**Request for Reconsideration:**

1. **Objection and Rejections.**

FIG. 4

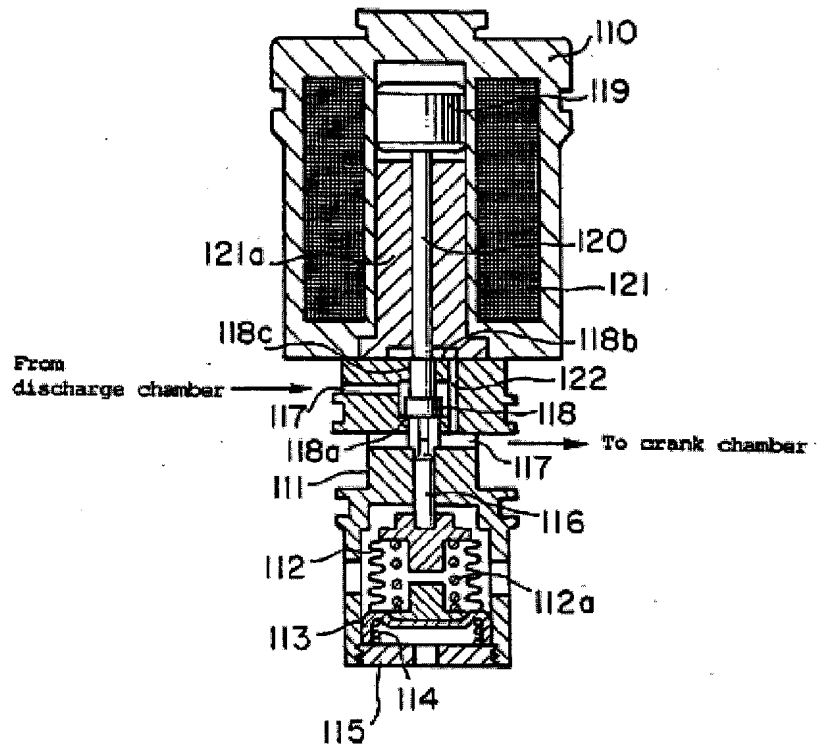
RELATED ART  add legend

The Office Action objects to the drawing because **Fig. 4** allegedly illustrates “only that which is old,” but lacks a legend, such as “Prior Art.” In addition, the Office Action objects to the specification because of some minor informalities. Claims 1-4 stand rejected under 35 U.S.C. § 102(a), as allegedly anticipated by Published Application No. US 2001/0003573 A1 to Kimura *et al.* (“Kimura”), which now has issued as Patent No. US 6,481,976 B2. Claim 5 stands rejected under 35 U.S.C. § 103(a), as allegedly rendered obvious by Kimura in view of U.S. Patent No. 5,332,365 to Taguchi (“Taguchi ‘365”). Applicant respectfully traverses.

The Office Action objects to the drawings because **Fig. 4** allegedly illustrates known displacement control valve, but is not designated by a legend, such as “Prior Art.” MPEP 608.02(g). Thus, Applicant is amending **Fig. 4** by adding the legend “Related Art.” Therefore, Applicant respectfully requests that the Examiner withdraw the objection to the drawings.
